# 802.3dj CR Calibration Suggestion

Remedy for comment #271

Sept 2025

# Noise Injection Methodologies' Challenges

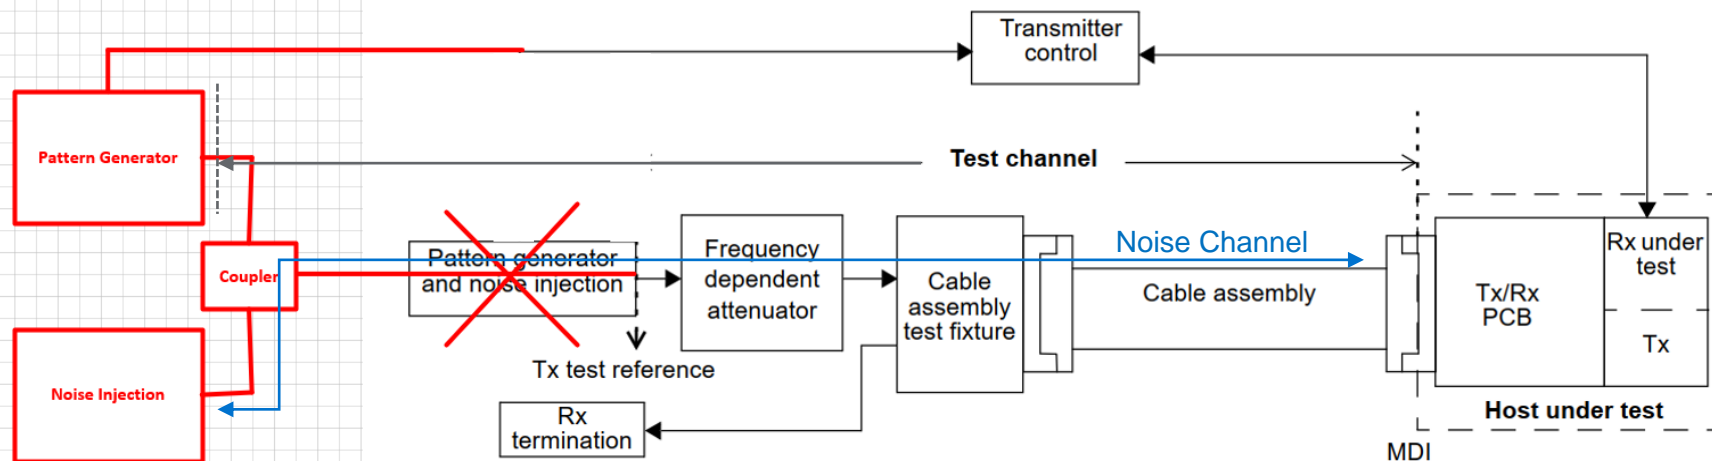
Injecting noise may follow one of these following paths:

1. Injecting noise taking advantage of connector coupling
  - i. Connector coupling may be minimal requiring substantial aggressor amplitude – May not be implementable to achieve target COM, may need additional amplifying of aggressor signals, etc.

- ii. Calibration may need to be iterative, use multiple connector lanes to insert aggression, etc. → Complex and somewhat not accurate
2. Use a coupler to inject the noise on the Tx side

- i. Signal after the coupler does not follow Tx or COM driver characteristics such as jitter, ISI, etc. → Need to provide two separate S4P interconnect paths (Very similar to KR)

- A. Through path from Tpt to receiver going through “THRU” path of the coupler
    - B. Crosstalk path from noise generator going through “crosstalk” path of the coupler

- ii. Methodology described in 2.i can be avoided if a signal generator has an integrated coupler which output follows Tpt characteristics – Methodology forces usage of specific equipment
